Amendments to the Drawings:

This Amendment is in response to the Office Action mailed February 15, 2007. Claims 26 and 27 are newly added. Claims 6, 7, 9, and 24 have been amended. No new matter has been added to the Application. Claims 1-5, 8, 10-13, 15-23, and 25 have been cancelled. Claims 6, 7, 9, 14, 24, 26, and 27 will be pending in this Application upon entry of this Amendment.

**FIG. 2** Prior Art**FIG. 3** Prior Art

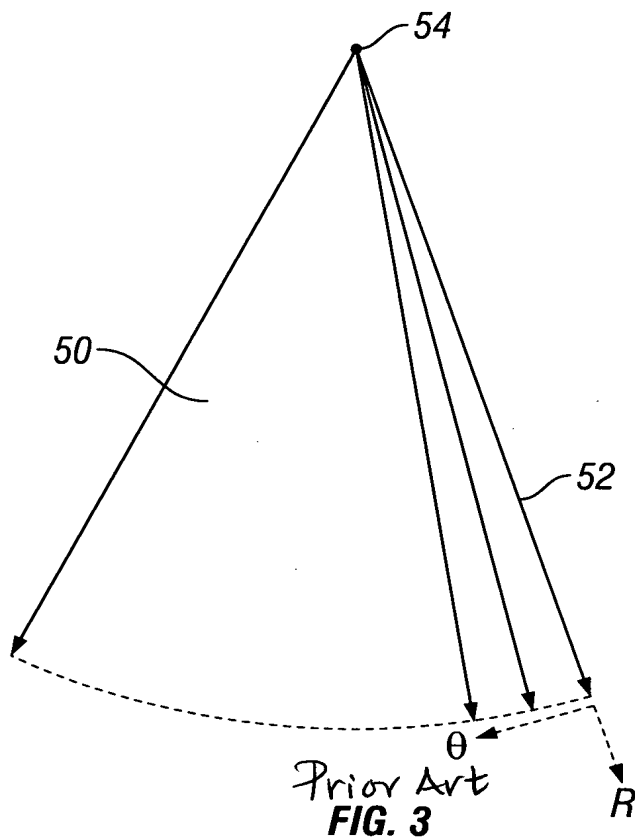
The notation "PRIOR ART" has been added to Figures 2-5 in the new drawing sheets. Also, Figure 2 has been changed to add reference numeral "12" thereto.

Figure 2 has been amended to include the reference numeral for beamformer 12. Accordingly, this objection should be withdrawn.

Replacement Figures 2-5 have been designated as "prior art," as required by the Office.

Prior Art
FIG. 4

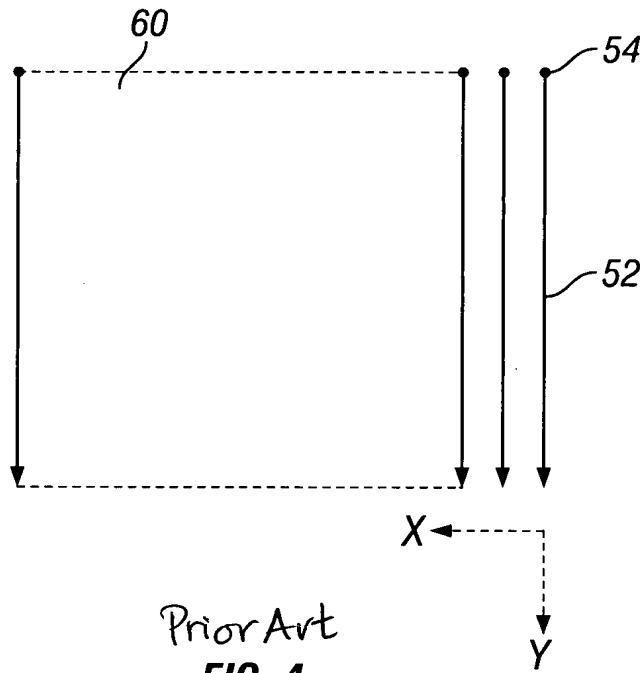
The objection to Figures 1-5 for not being designated as "prior art" is respectfully traversed.
